Broadcast Products Technical Bulletin 20-2006-035

SUBJECT: **POWER SUPPLY SHUTS DOWN MOMENTARILY**

MODEL: **BVM-D9H1A**
BVM-D9H1E
BVM-D9H1U
BVM-D9H5A
BVM-D9H5E
BVM-D9H5U

Figure 1

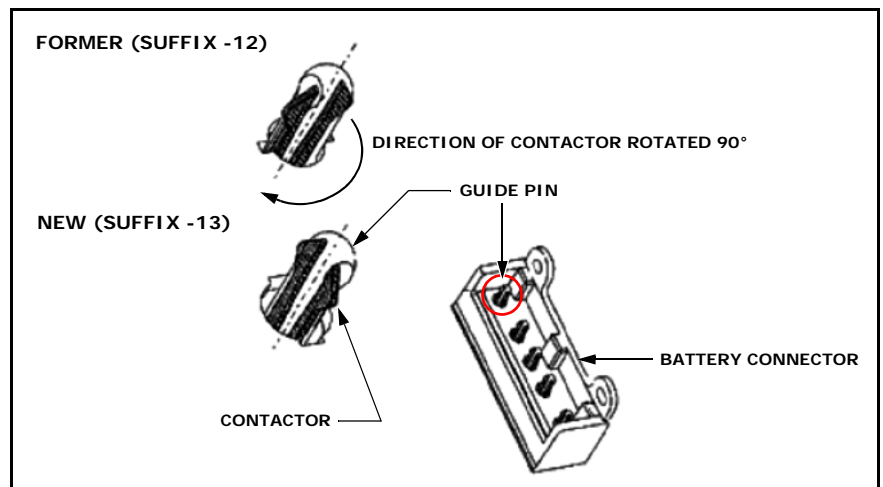
If the battery or AC adapter is subjected to excessive blows, the guide pin on the battery connector may bend, subsequently bending the battery connector contactor when the battery is reinstalled. As a result of insufficient contact, the power supply frequently shuts down for brief moments.

NOTE: The new battery connector is shaped differently and the contactor on the guide pin is rotated 90°. (See Figure 1.)

Replace the battery connector (1-766-377-12) with a new battery connector (1-766-377-13).
